Bypass Over Temperature Switches on XPM Series Ovens When Heater Panels That Do Not Support Over Temperature Switches Are Installed as Replacements.

XPM(1) and XPM2

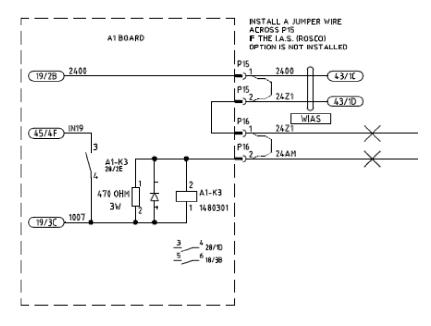
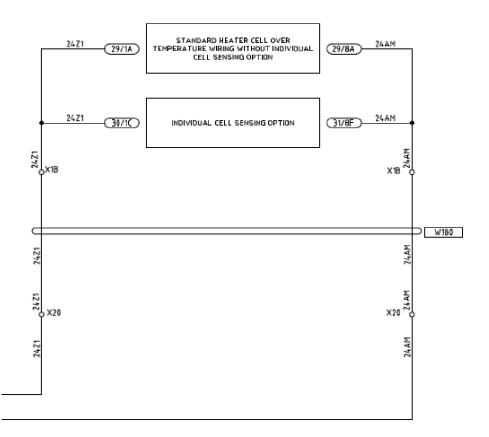
For the XPM3 ovens either follow procedure #1 above, or bypass the entire system. To bypass the entire system the oven controller software version must be version 02.12.01 or higher. If you do not have this version, you must perform an upgrade. It is recommended that you contact Vitronics Soltec for the latest PC and controller software versions. TO DISABLE THE OVER TEMP SWITCHES REMOVE AND ISOLATE THE "X" MARKED CONNECTIONS FROM CONNECTOR P16 ON THE A1 BOARD TO TERMINAL STRIP X20.

REPLACE THE BLUE WIRES ON CONNECTOR P16 ON THE A1 BOARD WITH A JUMPER WIRE INSTALLED BETWEEN P16 CONNECTOR POSITIONS 1 AND 2.

ISOLATE OR REMOVE THE BLUE WIRES LABELED 24Z1 AND 24AM THAT FORMERLY CONNECTED FROM CONNECTOR P16 ON THE A1 BOARD TO TERMINAL STRIP X20.
